ADDENDUM 4 – JOB 7

TO: All prospective bidders on project SU-3-982(031)035, NHU-3-019(044)155 & NHU-3-020(074)103, Job No. 7 scheduled for the October 14, 2016 bid opening.

ADDENDUM 4 JOB 7

TO: All prospective bidders and suppliers on Project NHU-3-019(044)155, NHU-3-020(074)103 & SU-3-982(031)035 scheduled for the October 14, 2016 bid opening.

STATE	PROJECT NO.	SECTION NO.	SHEET NO.
ND	NHU-3-019(044)155 & NHU-3-020(074)103 & SU-3-982(031)035	10	2

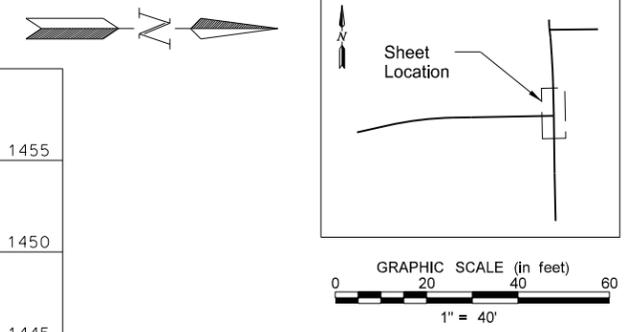
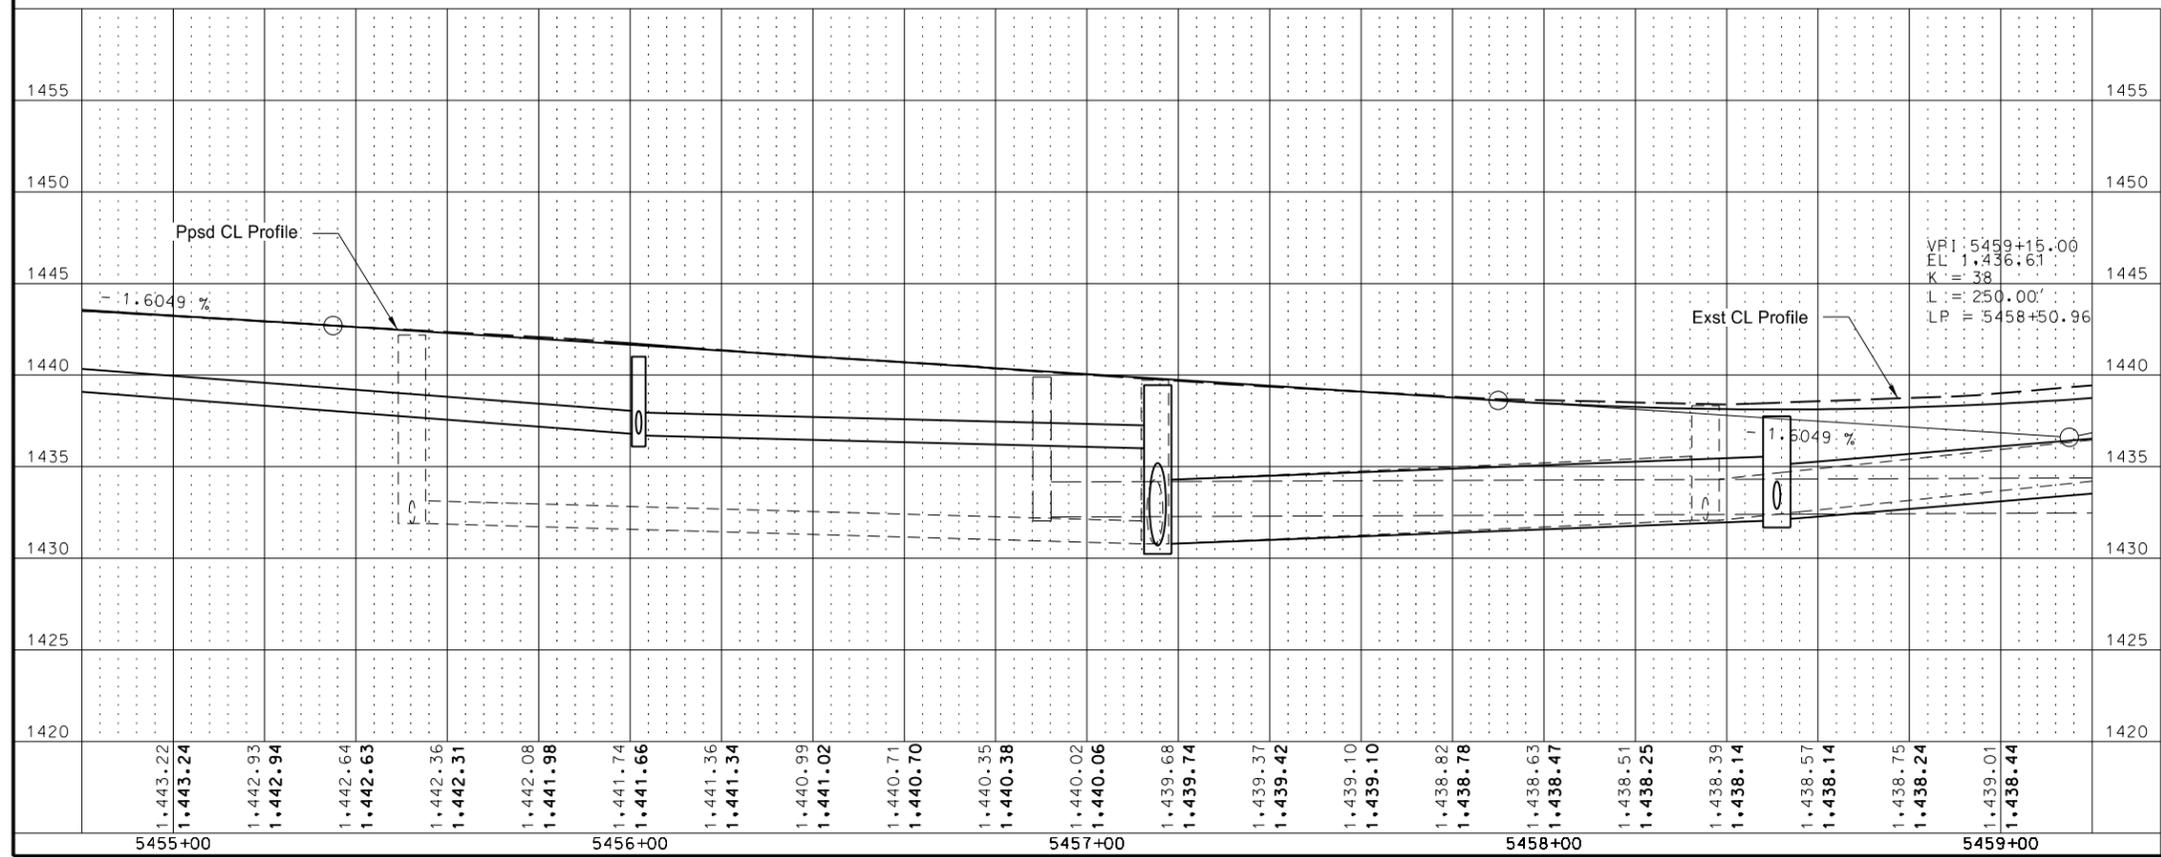
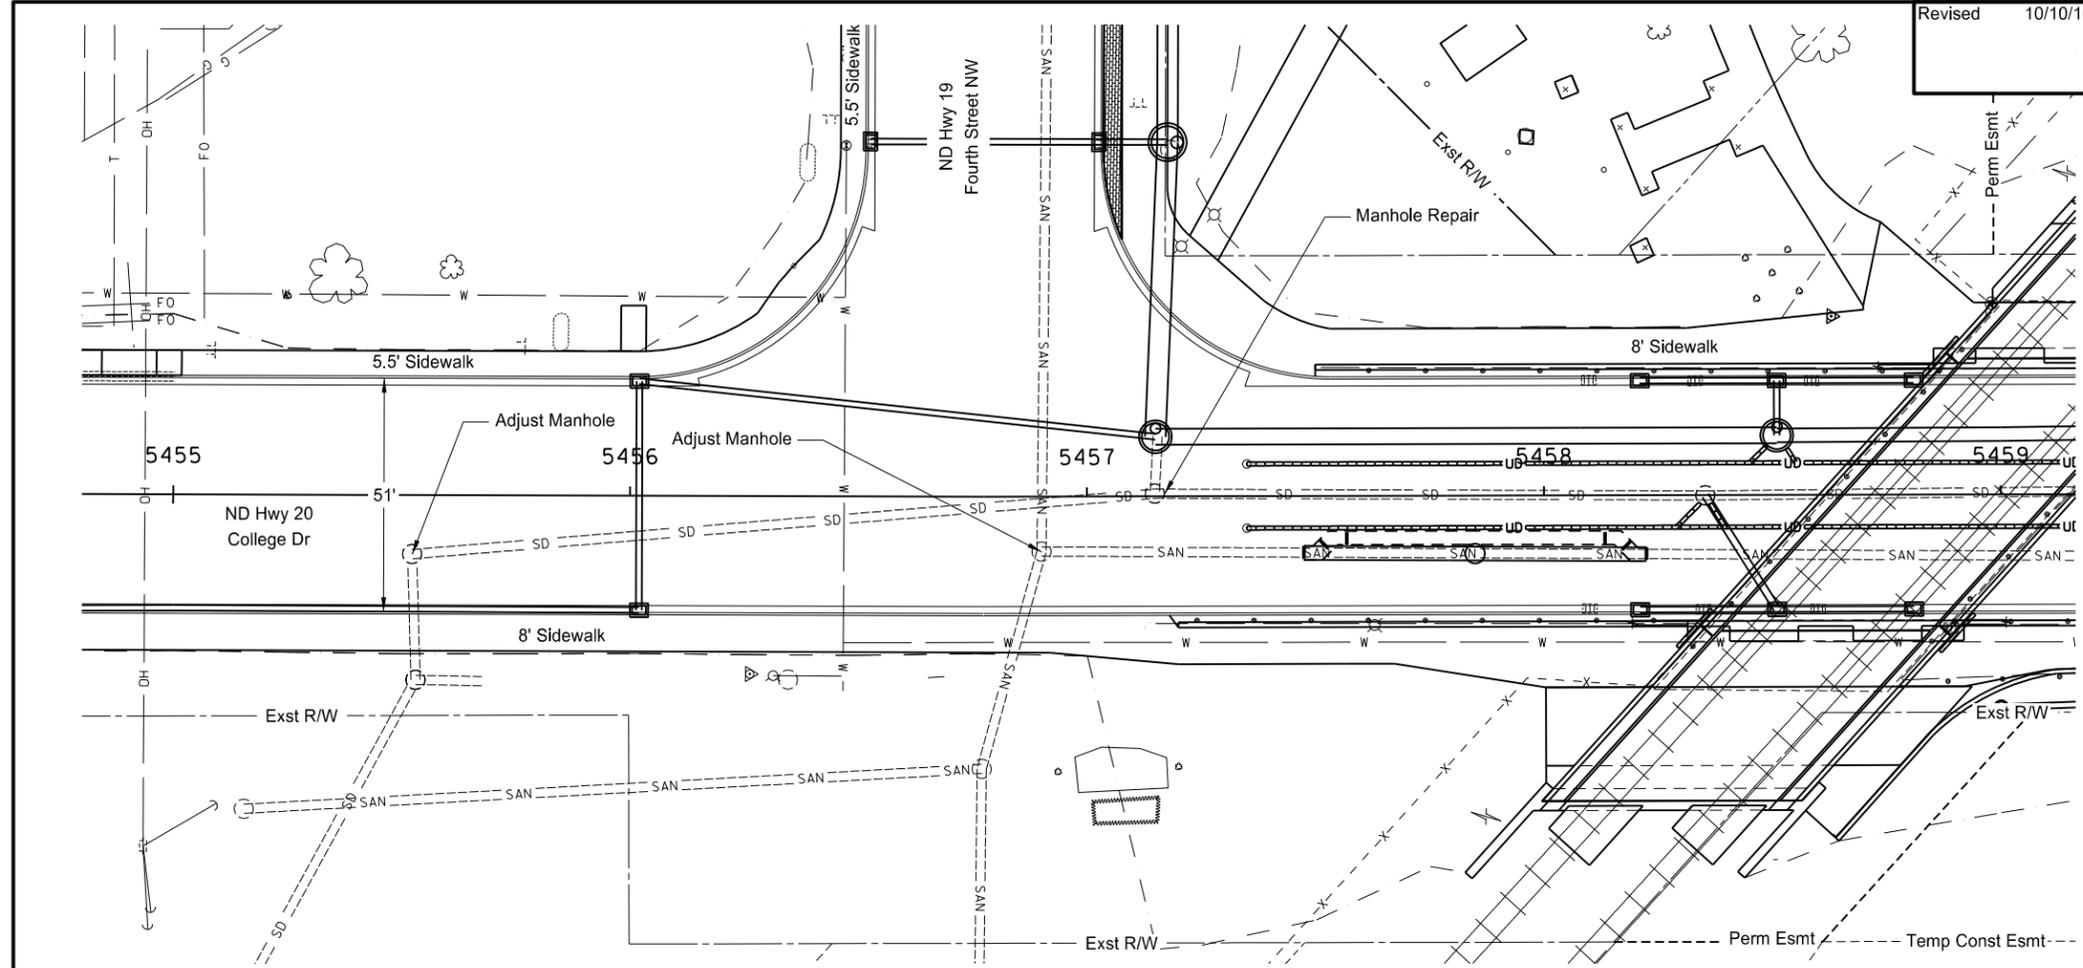
- Quantity of Geosynthetic Material Type G have been updated.

Geosynthetic Material Type G	Section 20 Sheet 15 = 521 SY Section 90 Sheet 1 = 2857 SY Total (ND 19) = 3378 SY	-	Section 20 Sheet 15 = 867 SY Section 60 Sheet 4 = 1018 SY Section 60 Sheet 5 = 216 SY Section 90 Sheet 1 = 8765 SY Total (ND 20) = 10866 SY	-	Total = 14244 SY
Curb & Gutter-Type 1	Section 90 Sheet 1 = 982 LF Section 100 Sheet 25 = 20 LF Total (ND 19) = 1002 LF	Section 90 Sheet 1 = 24 LF Total (ND 19 NP) = 24 LF	Section 90 Sheet 1 = 2886 LF Total (ND 20) = 2886 LF	-	Total = 3912 LF
Detectable Warning Panels	Section 90 Sheet 1 = 46 SF Section 100 Sheet 25 = 10 SF Total (ND 19) = 56 SF	Section 90 Sheet 1 = 20 SF Total (ND 19 NP) = 20 SF	Section 20 Sheet 15 = 50 SF Section 90 Sheet 1 = 162 SF Total (ND 20) = 212 SF	-	Total = 288 SF

ND Highway 20
 Plan & Profile
 Sta. 5455+00 to Sta. 5459+00

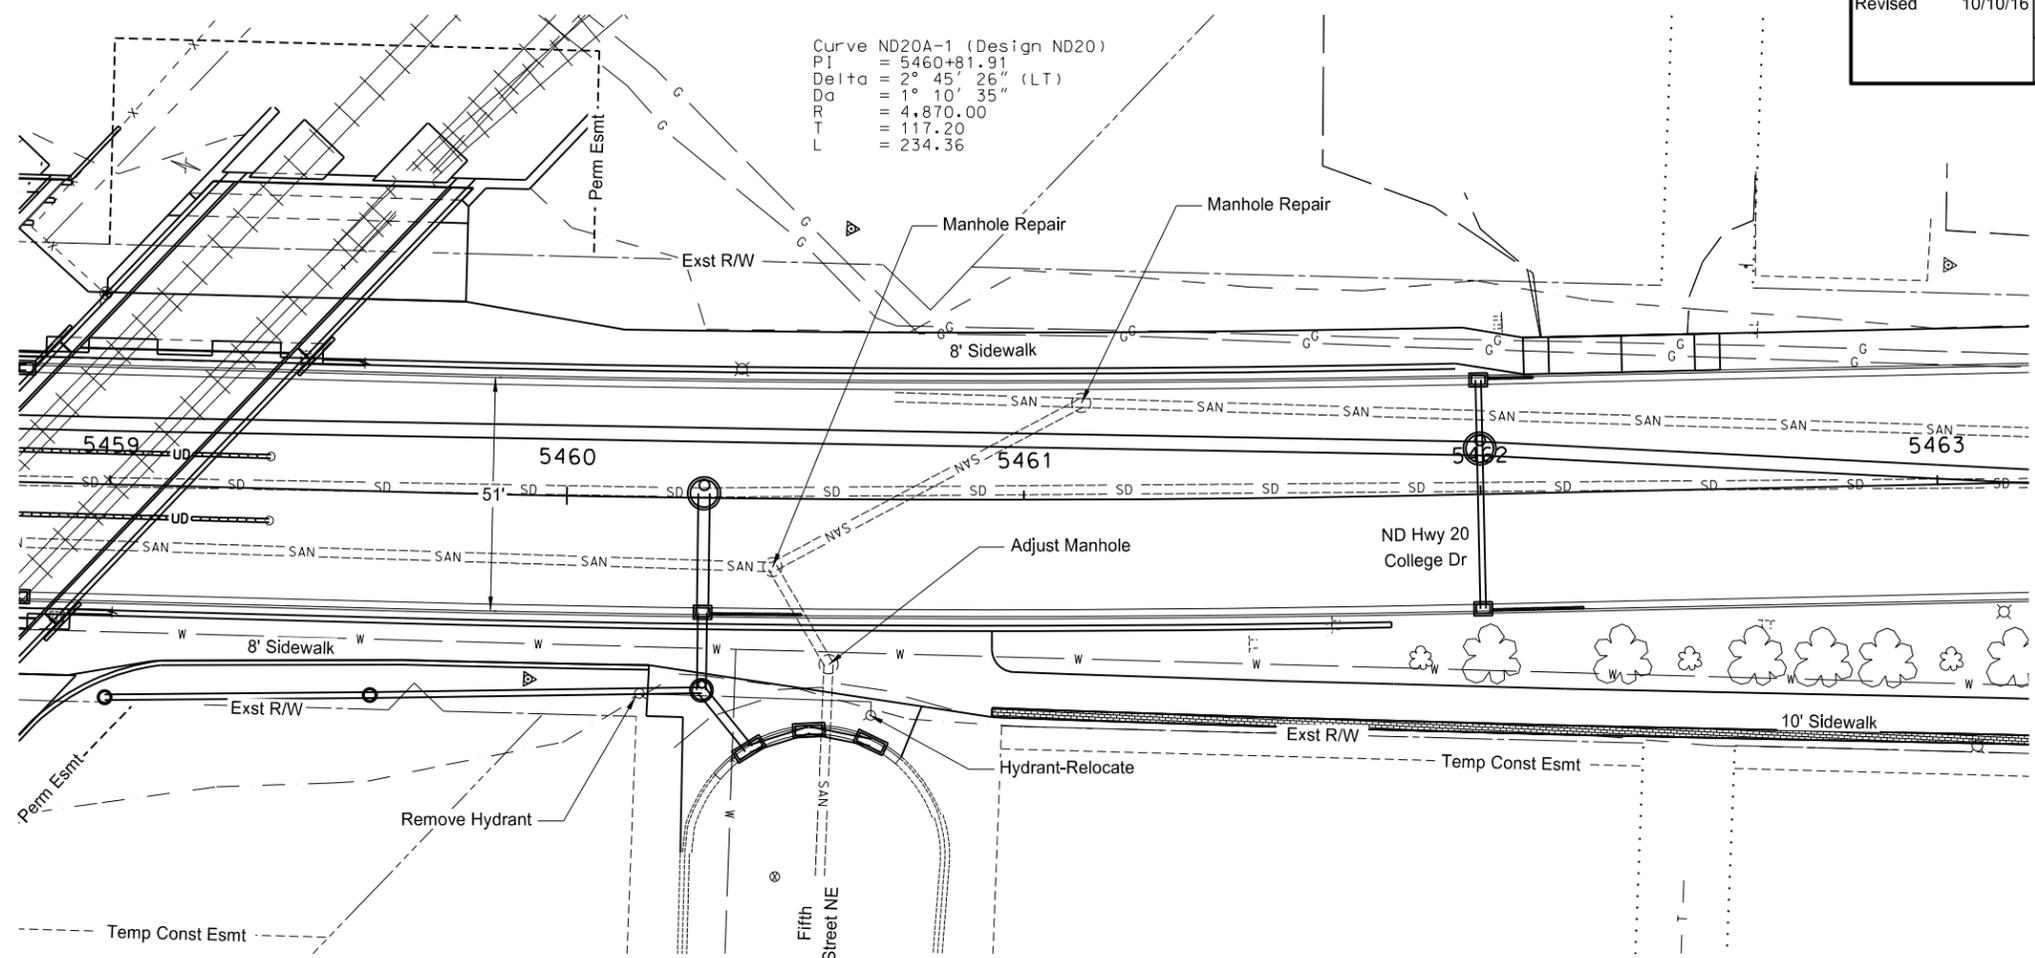
- Quantities of Geosynthetic Material Type G and Polystyrene Insulation Board have been updated.

Spec	Item Description	Qty	Unit
709 0100	GEOSYNTHETIC MATERIAL TYPE G Sta. 5457+35 to 5459+00	1018	SY
714 9696	EDGEDRAIN NON PERMEABLE BASE Sta. 5455+00 ~ 26' Rt to 5459+00 ~ 26' Rt Sta. 5455+00 ~ 26' Lt to 5456+48.70 ~ 57.93' Lt Sta. 5457+06.52 ~ 57.81' Lt to 5459+00 ~ 26' Lt	400 162 207	LF LF LF
714 9705	UNDERDRAIN CLEANOUT RISER Sta. 5457+35 ~ 7' Lt Sta. 5457+35 ~ 7' Rt	1 1	EA EA
714 9730	UNDERDRAIN PIPE PVC PERFORATED 6IN Sta. 5457+35 ~ 7' Lt to 5459+00 ~ 7' Lt Sta. 5457+35 ~ 7' Rt to 5459+00 ~ 7' Rt	165 165	LF LF
722 3410	MANHOLE REPAIR Sta. 5457+15 ~ CL	1	EA
722 6200	ADJUST MANHOLE Sta. 5455+52 ~ 15' Rt Sta. 5456+90 ~ 12' Rt Sta. 5458+35 ~ CL	1 1 1	EA EA EA
744 0100	POLYSTYRENE INSULATION BOARD Sta. 5457+35 ~ 7' Lt to Sta. 5459+00 ~ 7' Lt Sta. 5457+35 ~ 7' Rt to Sta. 5459+00 ~ 7' Rt	5280 5280	BDFT BDFT

ND Highway 20
Plan & Profile
 Sta. 5459+00 to Sta. 5463+00

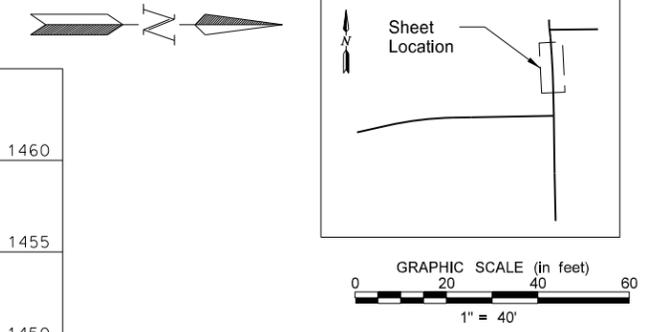
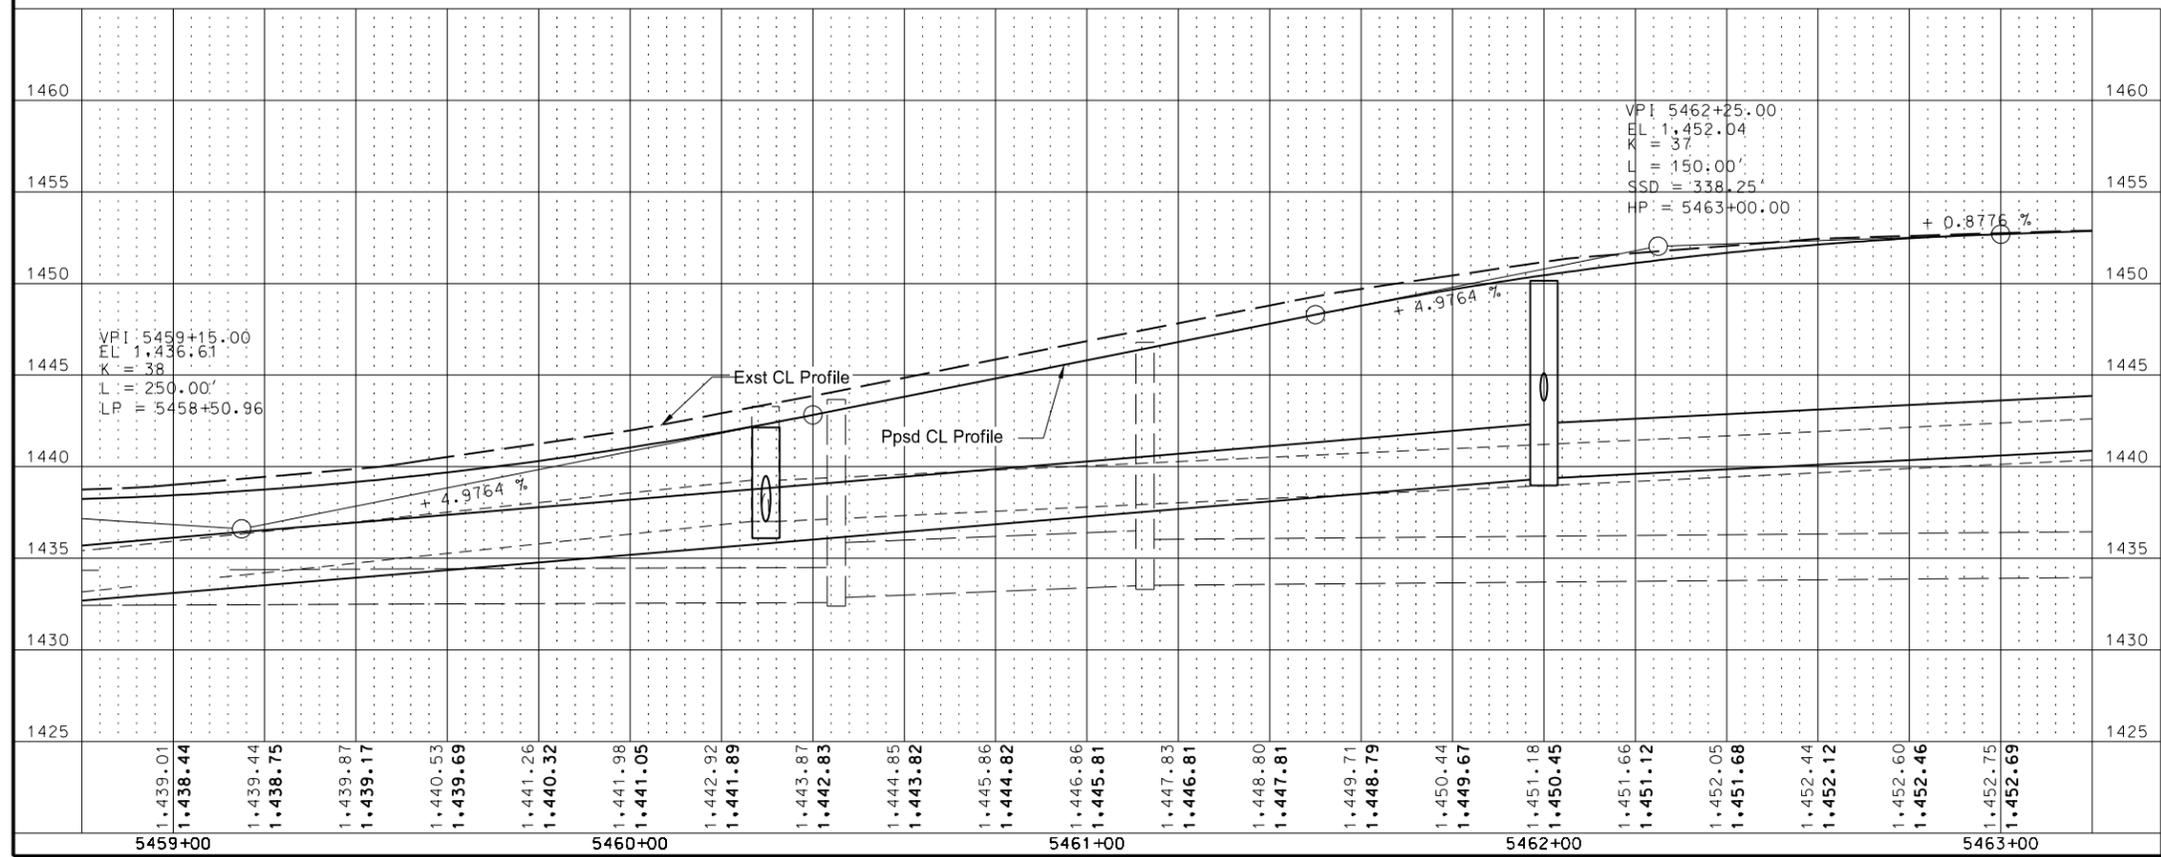
- Quantities of Geosynthetic Material Type G and Polystyrene Insulation Board have been updated.

Spec	Item Description	Qty	Unit
709 0100	GEOSYNTHETIC MATERIAL TYPE G Sta. 5459+00 to 5459+35	216	SY
714 9696	EDGEDRAIN NON PERMEABLE BASE Sta. 5459+00 ~ 26' Rt to 5463+00 ~ 26' Rt Sta. 5459+00 ~ 26' Lt to 5463+00 ~ 26' Lt	400	LF
714 9705	UNDERDRAIN CLEANOUT RISER Sta. 5459+35 ~ 7' Lt Sta. 5459+35 ~ 7' Rt	1	EA
714 9730	UNDERDRAIN PIPE PVC PERFORATED 6IN Sta. 5459+00 ~ 7' Lt to 5459+35 ~ 7' Lt Sta. 5459+00 ~ 7' Rt to 5459+35 ~ 7' Rt	35	LF
722 3410	MANHOLE REPAIR Sta. 5460+45 ~ 15' Lt Sta. 5460+58 ~ 36' Rt	1	EA
722 6200	ADJUST MANHOLE Sta. 5461+13 ~ 21' Lt	1	EA
724 0420	HYDRANT-RELOCATE Sta. 5460+67 ~ 67' Rt	1	EA
744 0100	POLYSTYRENE INSULATION BOARD Sta. 5459+00 ~ 7' Lt to Sta. 5459+35 ~ 7' Lt Sta. 5459+00 ~ 7' Rt to Sta. 5459+35 ~ 7' Rt	1120	BDFT
